MIL-C-38999/31B
AMENDMENT 1
27 March 1998

MILITARY SPECIFICATION SHEET

CONNECTORS, ELECTRICAL, CIRCULAR, PLUG, LANYARD RELEASE, FAIL-SAFE REMOVABLE CRIMP CONTACTS, PINS, SERIES III, SHELL SIZE 25, METRIC

This amendment forms a part of MIL-C-38999/31B, dated 10 June 1992, and is approved for use by all Departments and Agencies of the Department of Defense.

FIGURE 3. Plug, class J and M, type 3. "

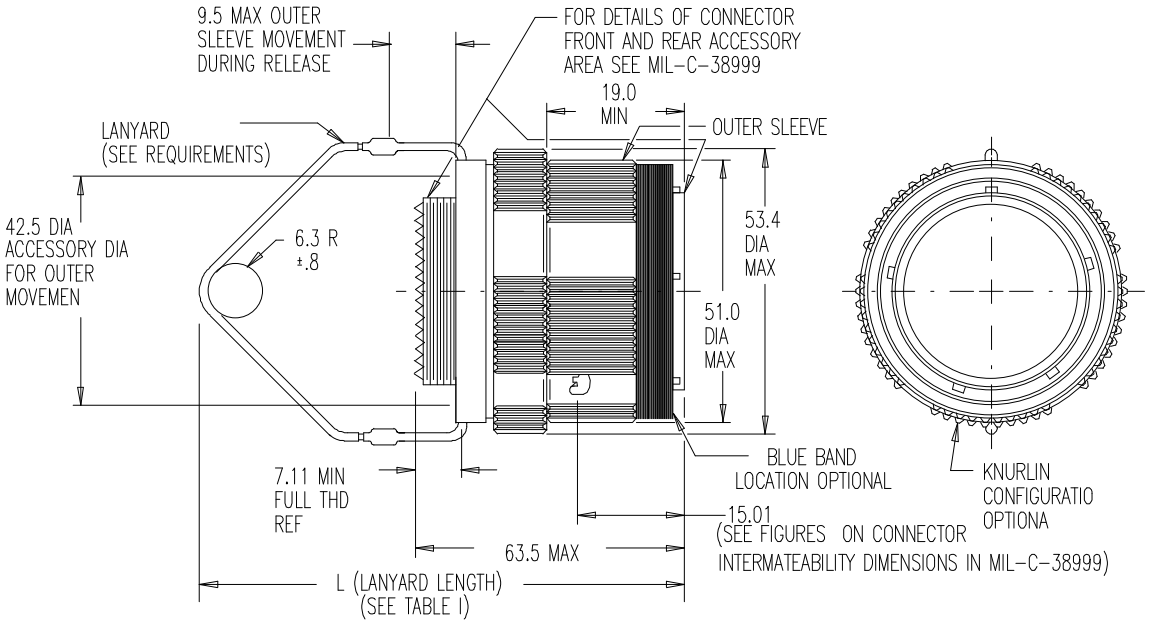
Add new figure 3 as follows:

NOTES:
1. Dimensions are in millimeters.
2. Inch-pound equivalents are given for information only.
3. Polarization position N is shown.
4. EMI grounding feature required on this connector.
5. The Government may stock, store, and issue this configuration.
6. This part may be used as a replacement for type I.

"For figure 3:

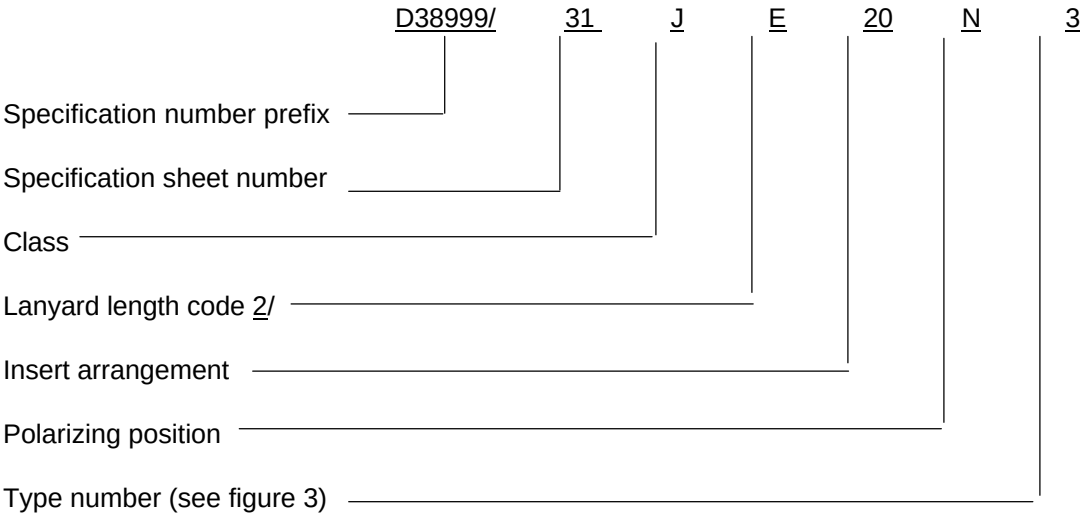
Following " For figure 2", add new PIN for figure 3:
